## Application for Mineral Mine Plan Revision or Amendment

Re: Adjustment to Approved Mine Plan Amendment. Drainage Detail Sentinel East Backfilling. Lisbon Valley Mining Company LLC. 920 South County Road 313, La Sal, Utah, 84530.

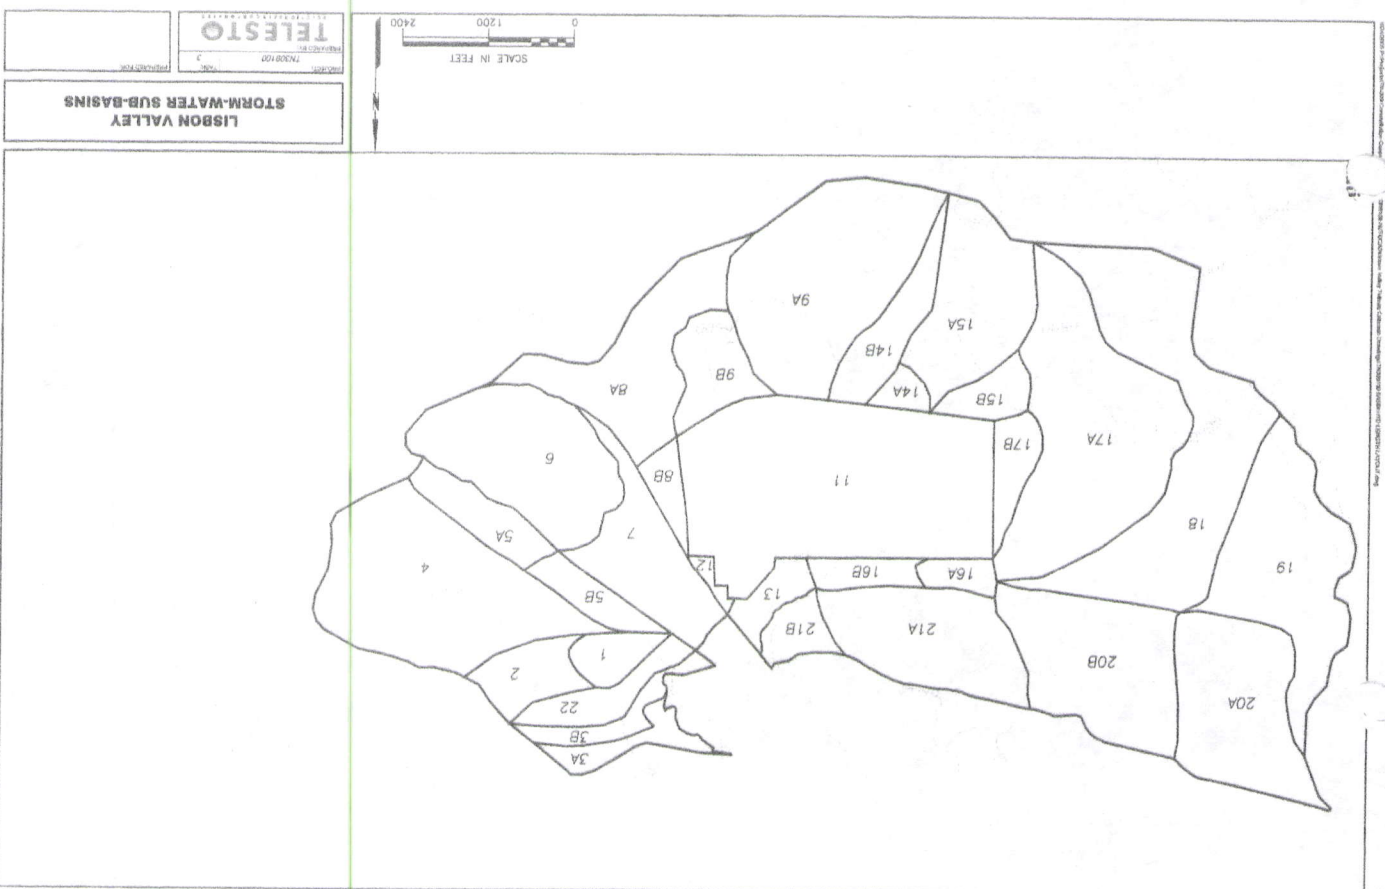
The Lisbon Valley Mining Co LLC (LVMC) has attached additional detail pertaining to diversion design around the toe of Waste Dump C. The embedded site plan on the following page shows the location of Diversion Channels C1 and C4.
